HISTORIC AND DESIGN REVIEW COMMISSION

October 05, 2016 Agenda Item No: 12

HDRC CASE NO: 2016-393 **ADDRESS:** 524 N PINE ST

TYPE OF WORK: Front yard fencing, skirting painting

Picture of existing color at gable walls being proposed for foundation wall

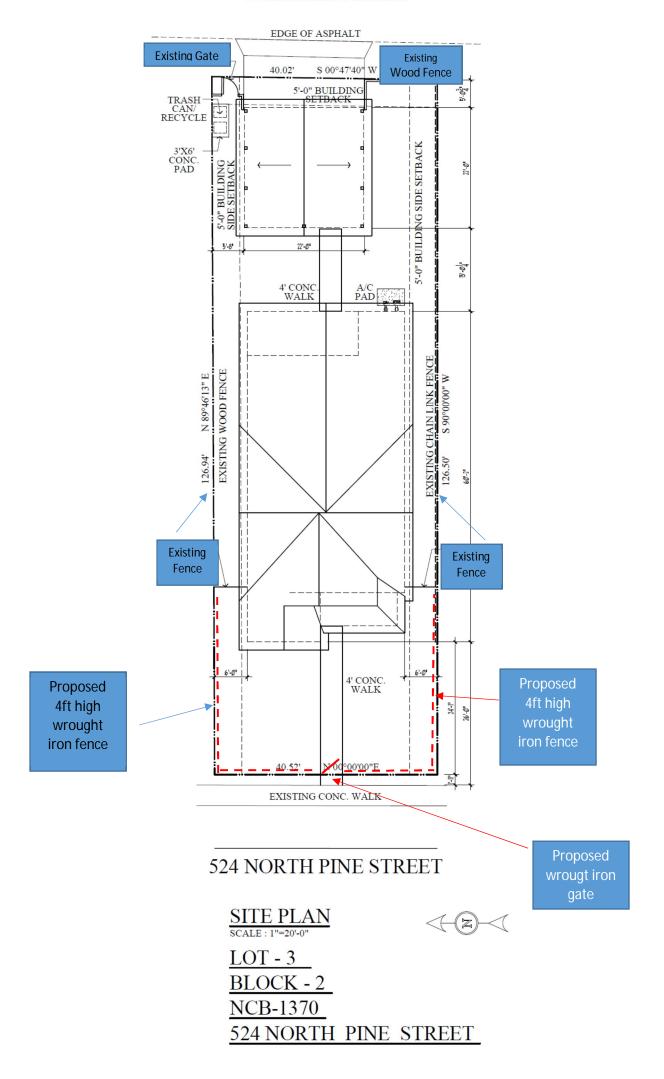
- c. The existing skirting is unpainted concrete foundation wall. The applicant is requesting to paint it dark grey, Stunning shade by Sherwin Williams. There are no Guidelines for colors. Staff finds the proposed color appropriate.

Staff recommends approval as submitted based on findings a through c with the following stipulations:

Existing design at railing to be used at proposed fence

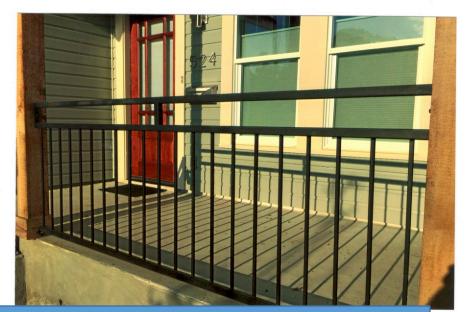
- b. There is not an existing front yard fence. There is a rear wood and chain link fence. The applicant is proposing to install a 4' tall front yard wrought iron fence with 4"x4" cedar posts at the corners and ends. According to the Guidelines for Site Elements 2.B., front yard fences should only be installed if the district historically had them and should be consistent with the location, height and design found in the district. Staff found that in Dignowity Hill Historic District, wrought iron fences would have been used when the neighborhood was established. Staff finds the proposed fence consistent with the Guidelines.
